FORT ST. VRAIN NUCLEAR GENERATING STATION

AMENDMENT TO FACILITY OPERATING LICENSE

Amendment No. 37
License DPR-34

AMENDMENT NO. 37 TO FACILITY OPERATING LICENSE DPR-34

FIGURE 6.3-2

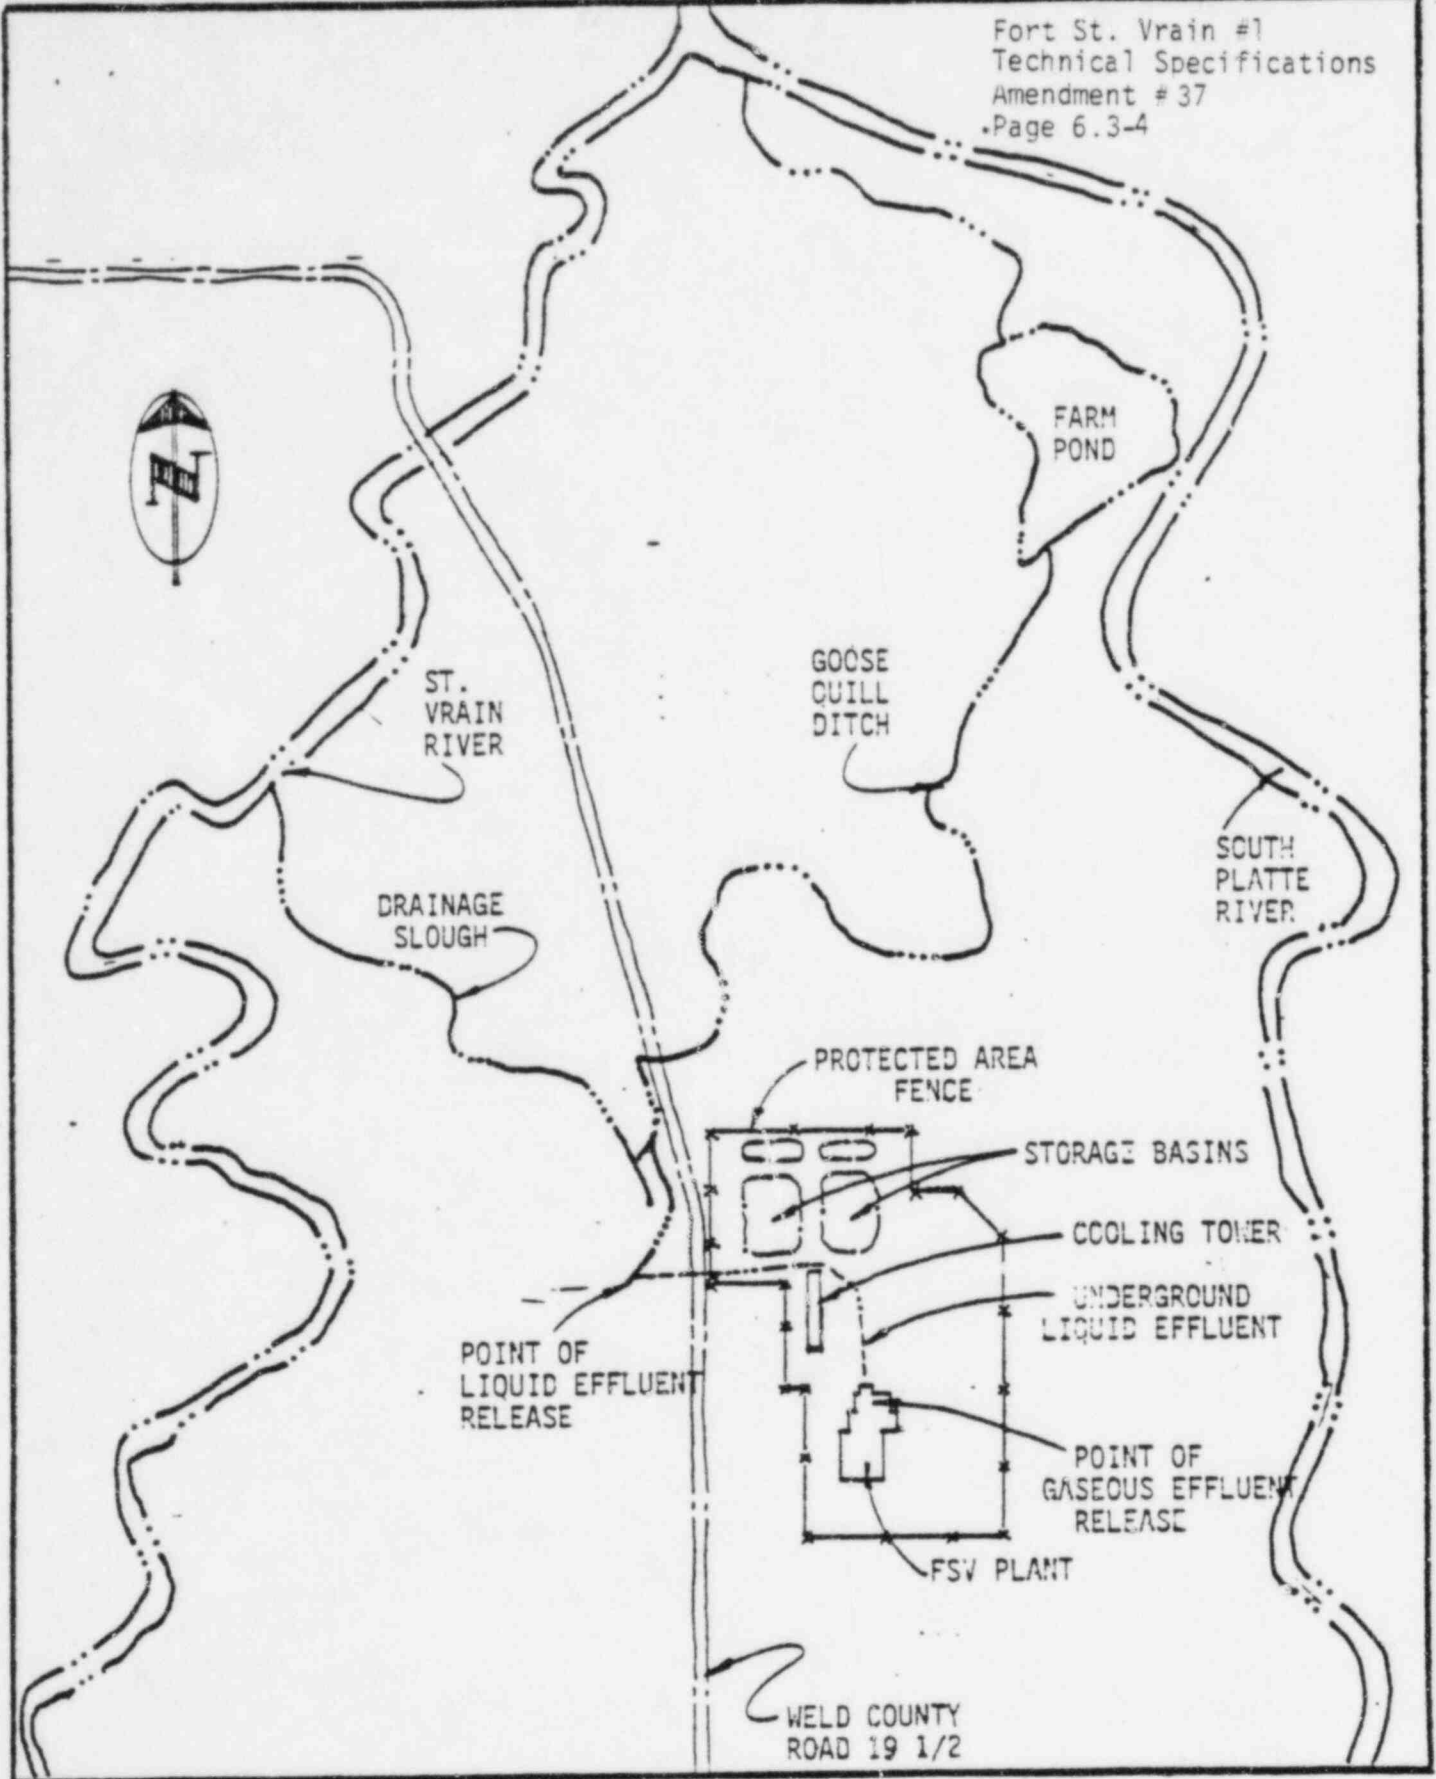
| Points where radioactive gaseous and liquid effluents are
| released are shown on Figure 6.3-2 as are the liquid
| effluent pathways leaving the site.
